Assessment of Proposed Repowering at LADWP Scattergood, Harbor, and Haynes Generating Stations

Bill Powers, P.E., Powers Engineering, January 21, 2019

Figure 1. Space at AES Alamos and Haynes Generating Station for 300 MW of battery storage

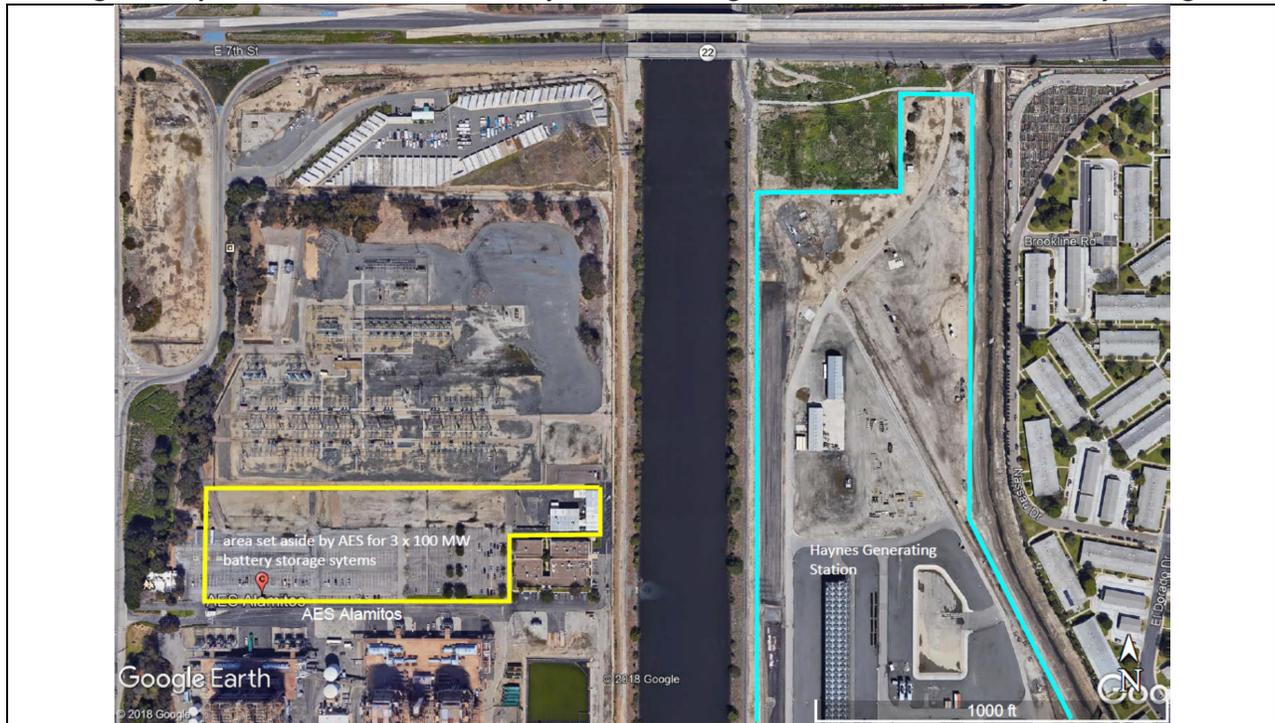
Battery storage is in the process of dominating gas turbines in peaker applications.^{22,23} AES is constructing a 100 MW battery storage system under contract to SCE at AES Alamos, across the San Gabriel River from the LADWP Haynes Generating Station. The area AES has designed for three 100 MW battery storage systems (300 MW total) at AES Alamos is shown in Figure 1. There is clearly at least as much available space directly across the river at the north end of the Haynes Generating Station for 300 MW of battery storage.

There is also no technical reason that battery storage could not be distributed on the Scattergood, Harbor, or Haynes generating station sites to eliminate space constraints, if they exist, for single large blocks of storage. For example, ten units of 10 MW each, that are dispersed throughout the power plant site, provide more locational flexibility than one contiguous 100 MW unit. However, there is no indication that any analysis of battery storage site constraints at Scattergood, Harbor, or Haynes has been conducted by LADWP or Navigant.
